# Access Compliance Report

## Public Rights-of-Way

### (Curb Ramps)

Intersection ID: 47442	Main Street: OROFINO_CT	Cross Street: KALISPELL_LN	Location: NW
ADA ID: 404DB77074C7	Ramp Type: PerpDiag	Initial Pass/Fail: Fail	Overall Compliance: No
Severity Score: 33.75			
Codes/Mitigation Info/Possible Solution		Field Measurements/Component Compliance

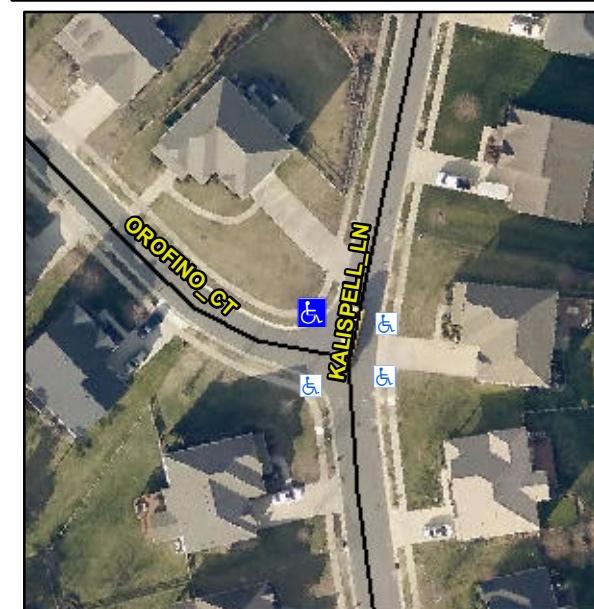
**Remove & Replace Curb Ramp With Two New Directional Ramps or Equivalent.**

**R304.5.1, R304.5.3**

Compliance	Description	Data	Compliance	Description	Data
N/A	Ramp Length (in)	48.0	Yes	Ramp Slope (%)	8.0
No	Ramp Width (in)	47.0	No	Ramp XSlope (%)	7.6
N/A	Flare Type LT	N/A	N/A	Flare Type RT	N/A
N/A	Flare Slope LT (%)	N/A	N/A	Flare Slope RT (%)	N/A
N/A	Flare Traversable LT?	N/A	N/A	Flare Traversable RT?	N/A
N/A	Landing Length (in)	N/A	N/A	DWS Provided?	N/A
N/A	Landing Width (in)	N/A	N/A	DWS Contrast?	N/A
N/A	Landing Slope (%)	N/A	N/A	DWS Length (in)	N/A
N/A	Landing X Slope (%)	N/A	N/A	DWS Full Width?	N/A
N/A	Landing Curb? (Y/N)	N/A	N/A	DWS Offset (in)	N/A
N/A	Shared Landing?	N/A			
N/A	Gutter Ponding?	N/A	N/A	Gutter Slope (%)	N/A
N/A	Gutter Lip Ht (in)	N/A	N/A	Gutter X Slope (%)	N/A
N/A	Painted X Walk1?	No	N/A	Painted X Walk2?	No
	X Walk 1 Direction	To S		X Walk 2 Direction	To E
N/A	X Walk 1 Width (in)	N/A	N/A	X Walk 2 Width (in)	N/A
	X Walk 1 Slope (%)	13.0		X Walk 2 Slope (%)	0.1
	X Walk 1 X Slope (%)	2.0		X Walk 2 X Slope (%)	10.9

N/A	Ramp inside XWalk1?	N/A	N/A	Ramp inside XWalk2?	N/A
	Road Slope (%)	6.4	N/A	Clear Space?	N/A
	Road X Slope (%)	12.7	N/A	Clear Space to XWalk (in)	N/A
N/A	Any Obstructions?	N/A	N/A	Storm Grate/Utility Hazard?	N/A
	Obstruction Type			Storm Grate/Utility Type	
		N/A			N/A
		Yes		Surface Condition? (G/P)	Good
